**RE: Cactus Patch Plaza
7801 La Morada Place NW
Grading and Drainage Plan
Engineer's Stamp Date: 05/14/24
Hydrology File: H10D034**

**RE: Cactus Patch Plaza
7801 La Morada Place NW
Grading and Drainage Plan
Engineer's Stamp Date: No Date
Hydrology File: H10D034**

Based upon the information provided in your submittal received 04/25/2024, the Grading & Drainage Plan **is not** approved for Building Permit and Grading Permit. The following comments need to be addressed for approval of the above referenced project:

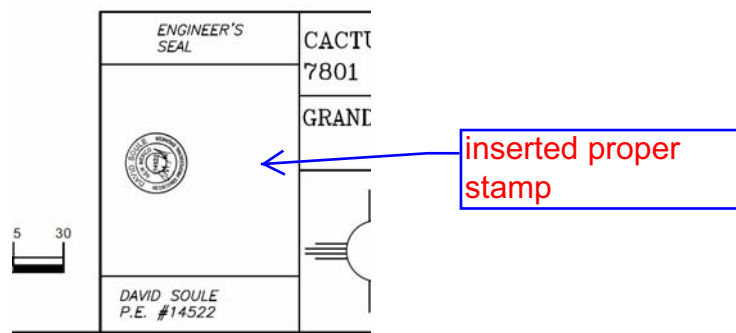
1. Please provide an engineer's stamp with a signature and date. The seal that was provided was missed sized and rotated wrong.

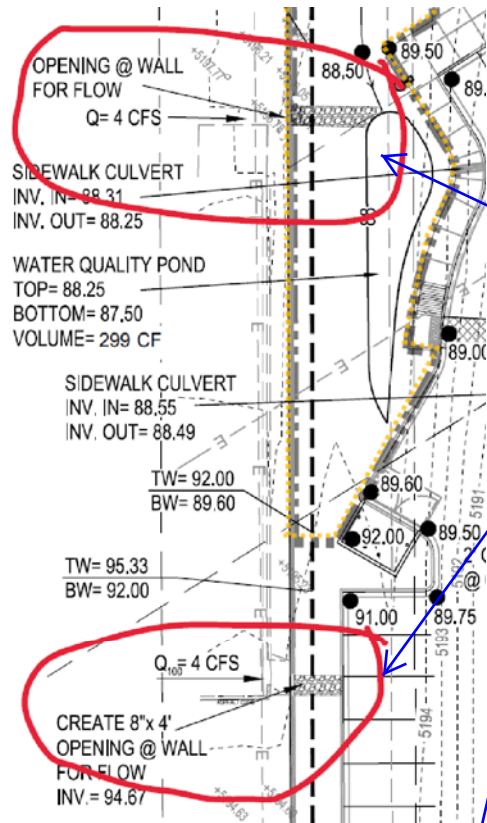
2. Please provide a section for this opening in the retaining wall. Also, please provide the opening calculations per the weir calculations, per DPM Article 6-16(A).

added calculation

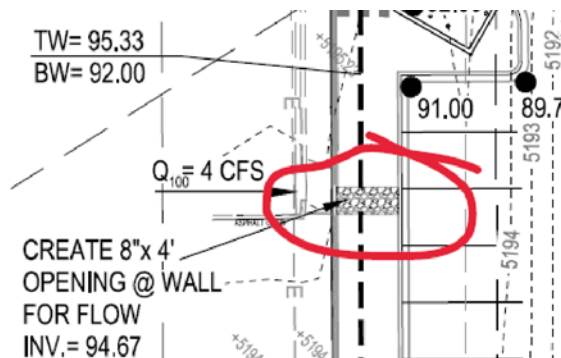
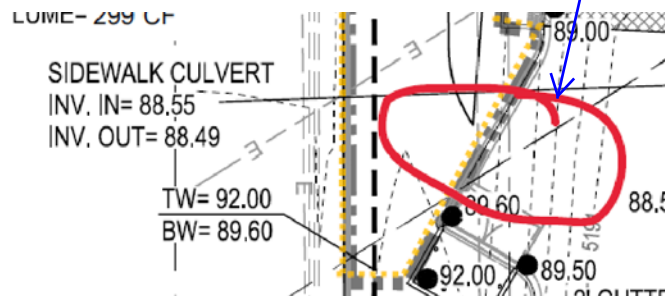
3. Please provide a curb cuts for the offsite flows (4 cfs).

added private
storm drain with
inlets at each
concentration and
overflows

← ADDED

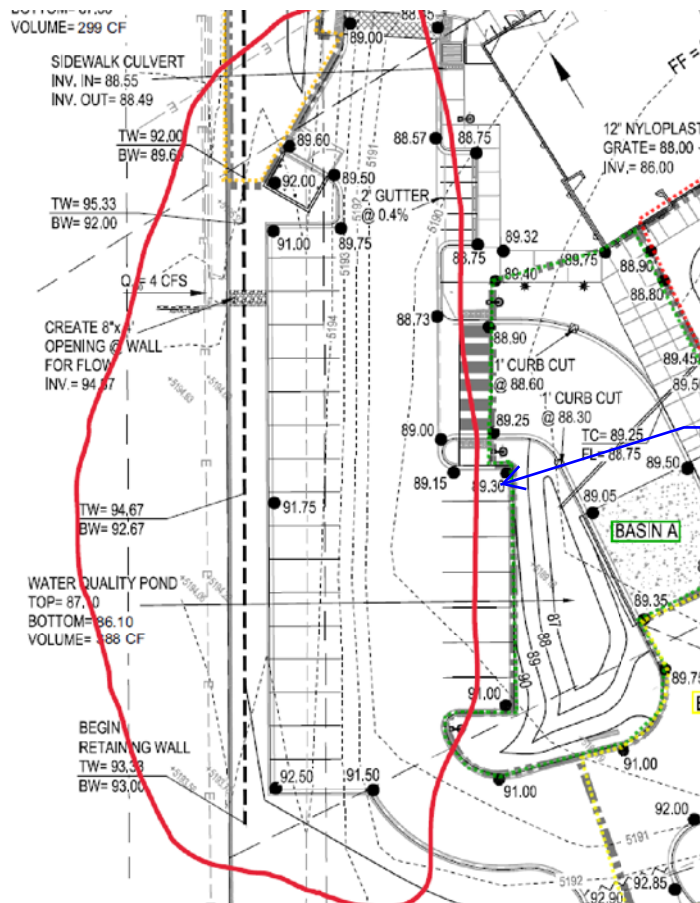
- How does this drainage area get into the provided stormwater quality pond? It appears that this entire paved parking and access road does not drain into a pond.

LOWERED THIS
SPOT TO
CAPTURE FLOW

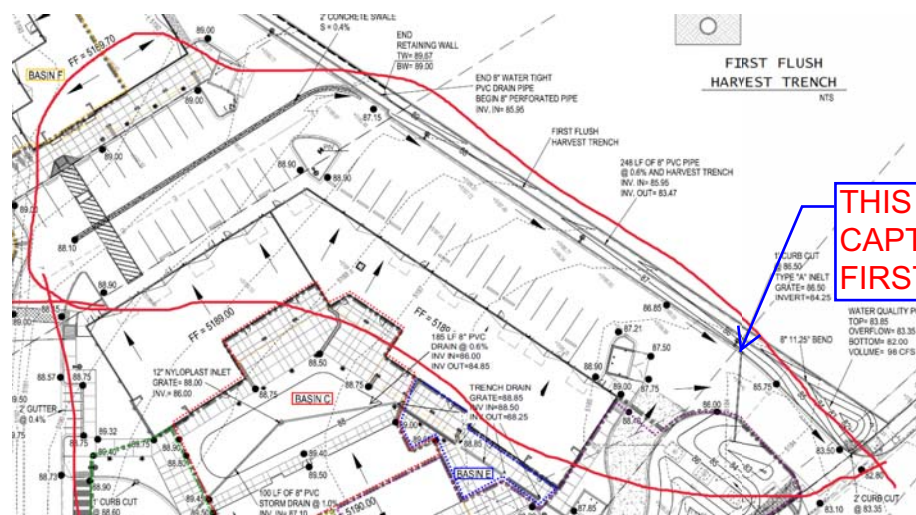
- How does this drainage area get into the provided stormwater quality pond? It appears that this entire paved parking and access road does not drain into a pond.

THIS INLET
CAPTURES THE
FIRST FLUSH
